97 Replacement fuse panel SA/SB has no power distribution bar (SA panel)

97 14 44 2037079/1 April 29, 2014.

Model(s)	Year	VIN Range	Vehicle-Specific Equipment
A3	2009	All	Not Applicable

Figure 1. The power distribution bar or “current rail” (A).

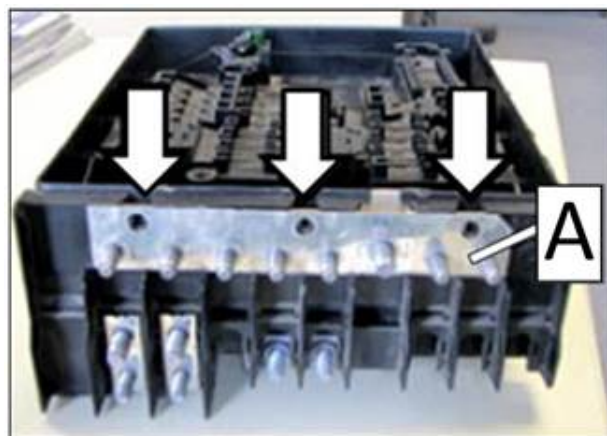
The replacement service part for the SA/SB fuse panel (located under the hood inside the engine bay) does not have the metal SA power distribution bar or “current rail” (Figure 1).

The under-hood fuse panel (SA/SB assembly) with part number 1K0 937 125 A or 000 937 125 is supplied without the power distribution bar.

When the fuse panel is replaced with one of these parts, the power distribution bar from the original fuse panel must be re-installed on the new fuse panel.

Figure 2. The power distribution bar or “current rail” (A).

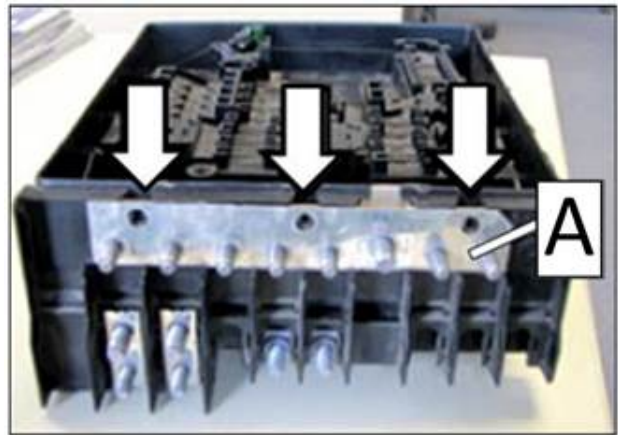
1. Carefully remove the power distribution bar from the original fuse panel by using a suitable tool such as a small pocket screwdriver in the area of the three arrows shown in the image at right (Figure 2).

2. Install the power distribution bar from the original fuse panel to the new replacement SB panel.
3. A 30A fuse must be used in position SB16 (Figure 3) after the new fuse panel assembly is installed.
